**SURFACE WATER FLOW HAZARDS
AROUND THE EXPLORATORY SHAFT FACILITY**

REVIEW OF SAND85-0598

**BY:
E. ROVEY, P.E.**

Figure 1. PMFs and Regional Floods.

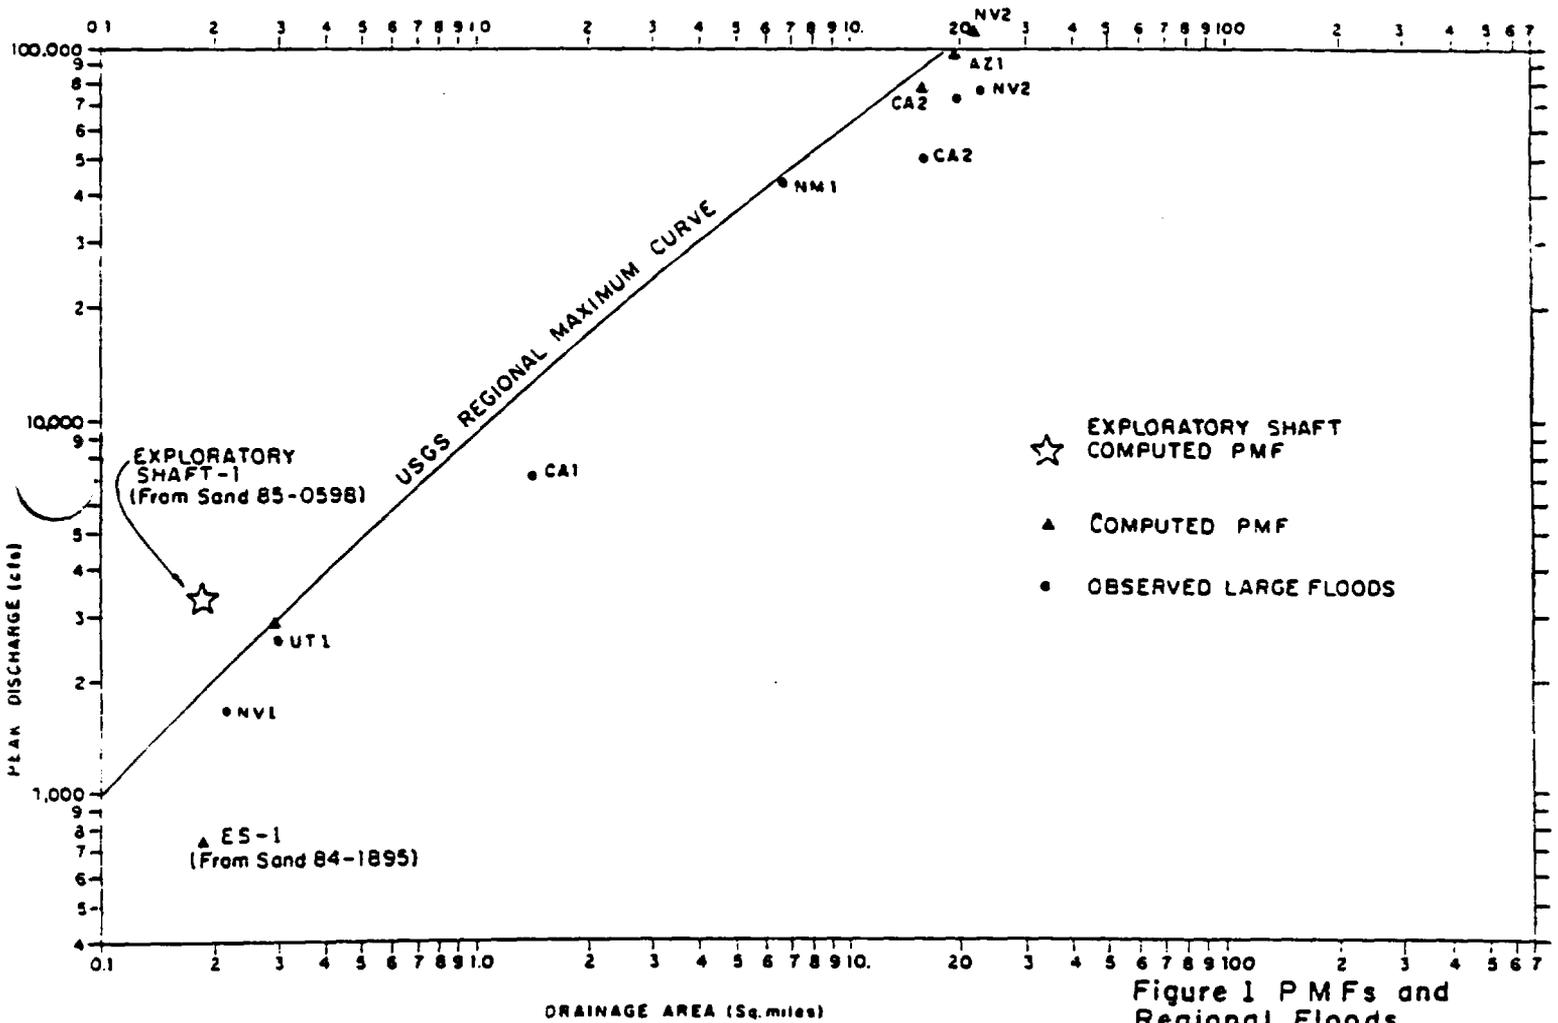
There is an explanation of the derivation of Figure 1 and further discussion regarding it in Section 5.0 of this review. The underestimation of the thunderstorm PMF is apparent when comparing the calculated PMF peak flow rate to the estimated 500-year flow of 24 cu.m/sec (850 cfs) for the Exploratory Shafts location. The 500-year peak was estimated by Squires and Young (1984) based upon a regression analysis of observed peaks in the region. Few hydrologists will agree on a recurrence interval for a PMF, or even if the concept of a recurrence interval is appropriate for a PMF. However, when there is general discussion of some a recurrence interval for a PMF, it is normally in the interval of once in 10,000 to once in 1,000,000 years. If a PMF has this low probability of occurrence (1×10^{-4} to 1×10^{-6} in any given year), it certainly would have a discharge rate substantially greater than the 500-year flood.

Figure 1 is a graphical presentation of some extreme floods that have been observed in the western United States areas that are hydrologically similar to the NNWSI area. Details about each flood are given in Table 1. The figure also contains the regional maximum curve as originally developed by Crippen and Bue (1977) and used by Squires and Young (1984) in their evaluation of flood potential for the NNWSI area. Subsequent to these two studies, Bullard (1986a) computed PMF based upon appropriate PMPs at many locations in the United States that had experienced very large historical floods. Some of the locations Bullard evaluated were the same ones used in the Crippen and Bue and Squires and Young studies. These computed PMFs are also plotted in Figure 1. Conclusions regarding PMFs in the region are as follows. The USGS regional maximum curve (Crippen and Bue, 1977) was developed to "envelope" the observed major floods shown in Figure 1 for the drainage basin sizes ranging from 0.22 to 25 square miles. Subsequently calculated PMFs by Bullard (1986a) for some of the same basins as observed major floods show that the PMFs all plot on or slightly below the USGS envelope curve with the exception of the Eldorado Canyon flood (NV2). The calculated PMF is 110,700 cfs while the envelope curve is about 108,000 cfs for the Eldorado Canyon site. All computed PMFs are larger than the observed flood peaks, which gives a degree of credibility to the concept of the PMF being at or near the upper bound of physically realistic floods. Figure 1 shows two estimates of the PMF peak flow rate for the exploratory shaft site. The original peak flow of 750 cfs (SAND84-1895) based upon the one hour thunderstorm from the USBR (1974) source is significantly under the envelope curve of maximum regional floods. However, the subsequent

estimate by Bullard (1986b) of PMF peak flow of 3350 cfs at the exploratory shaft and used in the SAND85-0598 document plots well above the envelope curve of Figure 1. This gives a degree of confidence that the currently used PMF at ES-1 is a conservatively high estimate of the probable maximum flood.

FIGURE 2
ES-1 SCHEMATIC

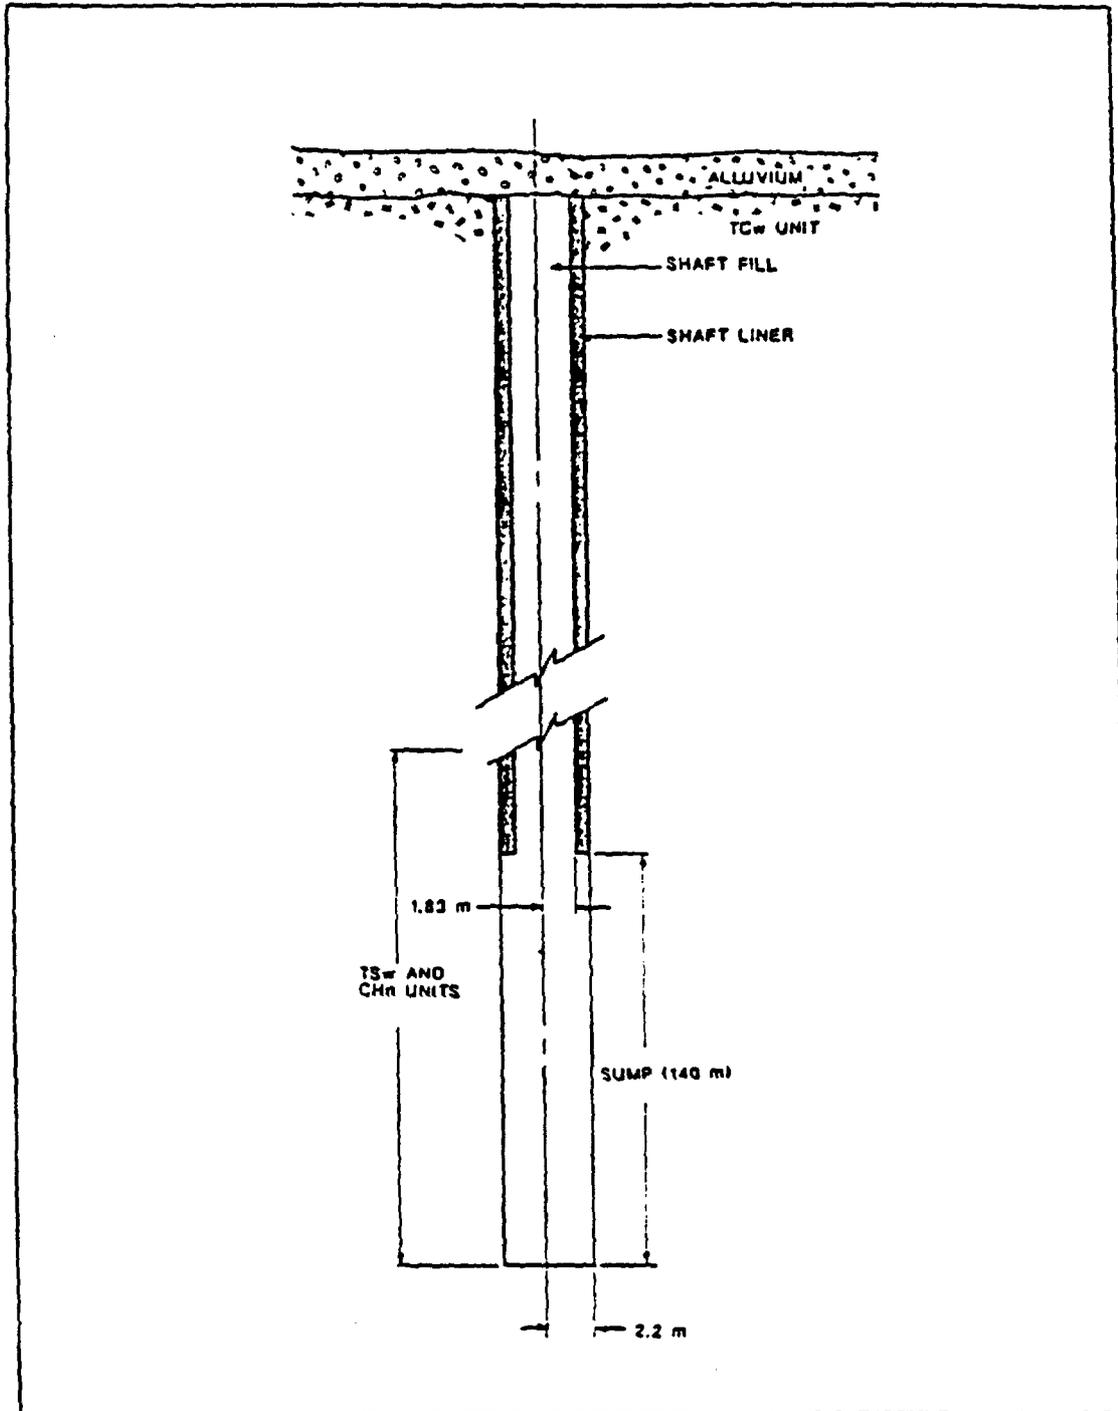
One extreme of flow of water into the shaft occurs when the shaft fill and the TCw unit have equal hydraulic conductivities (see Figure 2). The total flow into the shaft is then proportional to the ratio of the area of the shaft to the area of the alluvium. It was assumed the radius of ES-1 was 1.83 meters at the surface. The volume of water which would enter the shaft under these conditions and assumptions was calculated at 1,015 cubic feet.

Figure 1. Plot of hydraulic conductivity versus porosity for samples from boreholes G-4 and GU-3.

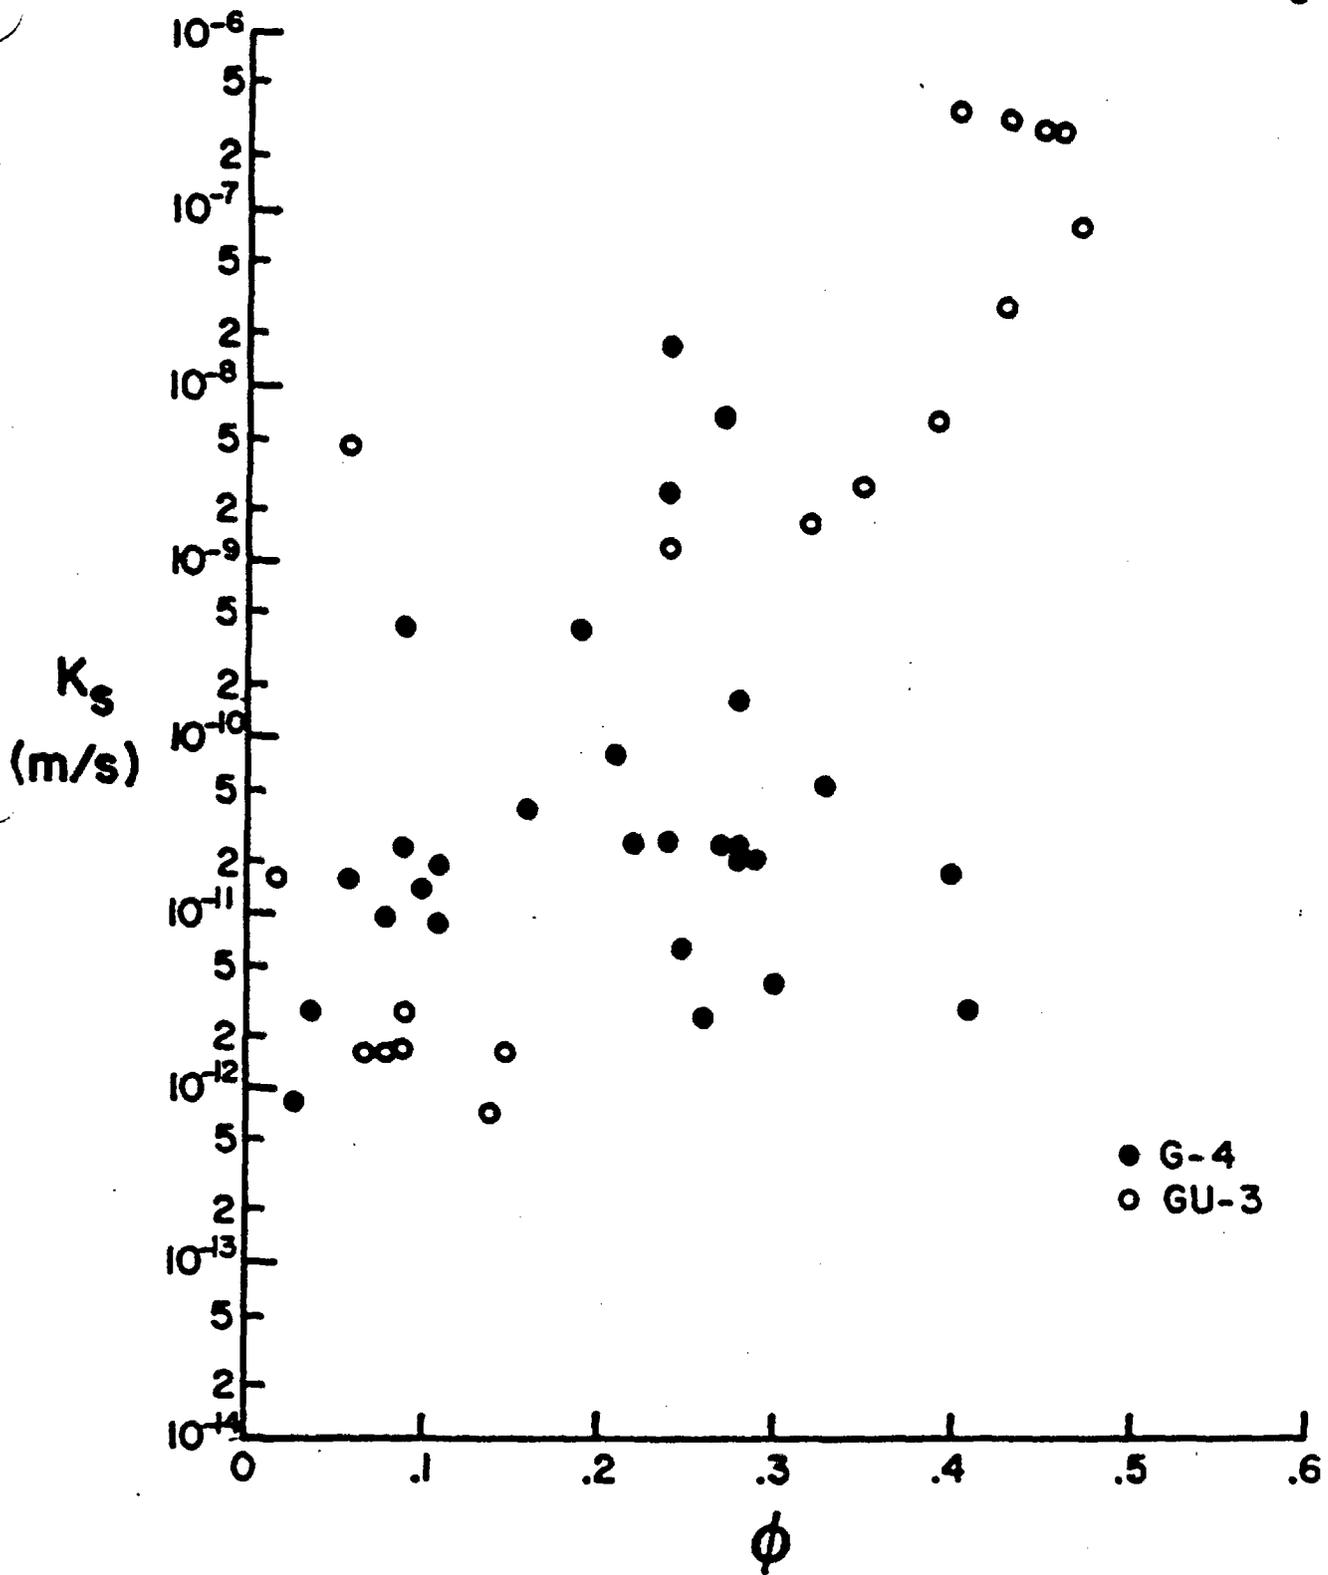
The results of the simulation process are presented in the form of contour maps showing the spatial distribution of travel times, histograms showing the number of flow paths in the calculational model, curves of cumulative distribution functions, and tables of means of standard deviations of sets of travel time values. Probably the most significant presentation of these data is the cumulative distribution curves which show the effect of using

mean values of effective porosity and hydraulic conductivity as opposed to using several realizations and selections from the distributions of porosity and hydraulic conductivity.
